“Full deskew” issue for Clause 177

- This is a follow-up contribution of [nicholl_3dj_optx_01_241017](#), addressing the issue when implementing “full deskew” for 800G/1.6T in Clause 177 (IMDD InnerFEC).

Functional Block Diagrams in D1.2

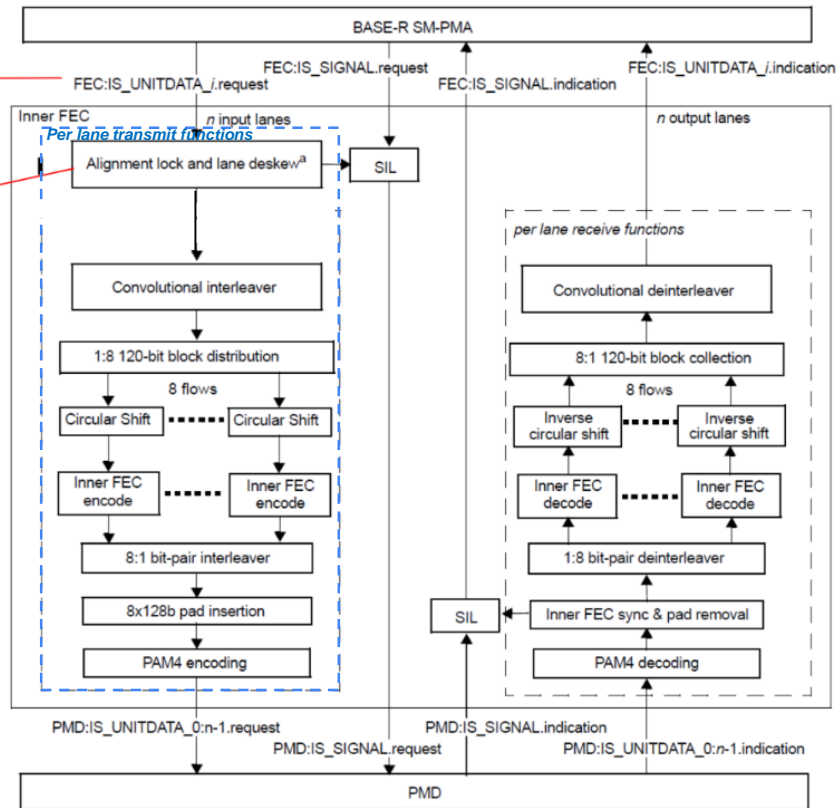
Newly added “alignment lock and lane deskew” function (in response to comment #159).

- In order to perform the PCS lane deskew function the 200G input lanes would first have to be symbol-demuxed back to PCS lanes (essentially un-doing the symbol muxing of the SM-PMA layer above)
- Then deskew performed on the PCS lanes
- And finally, the PCS lanes symbol-muxed back to 200G lanes (repeating the function of the SM-PMA layer above).

Proposed New Functional Block Diagrams for 177.4.1

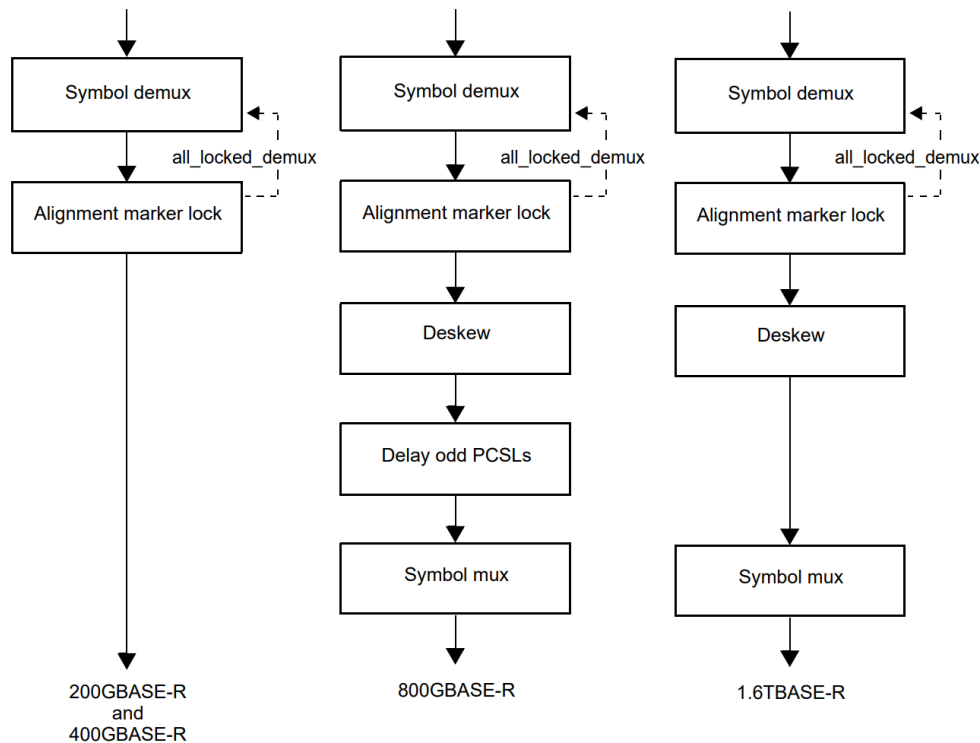
Three different processing flows are shown:

- For 200GBASE-R and 400GBASE-R, symbol-quartet boundary needs to be identified. However deskew and actual demux are not needed.
- For 800GBASE-R, alignment marker lock and deskew are needed, plus a 10-bit delay on odd lanes to remove the checkerboard pattern produced by PCS.
- For 1.6TBASE-R, alignment marker lock and deskew are needed.

177.4.1 Alignment lock and deskew

In order to maintain the full 12 RS-FEC codeword interleaving depth for the convolutional interleaver, alignment marker lock and deskew is provided.

Alignment marker lock is required to determine the RS-FEC 4-symbol and codeword boundaries. In addition, 800GBASE-R and 1.6TBASE-R PHYs must also deskew PCS lanes within each input lane and recombine the PCSs for proper operation of the convolutional interleaver.
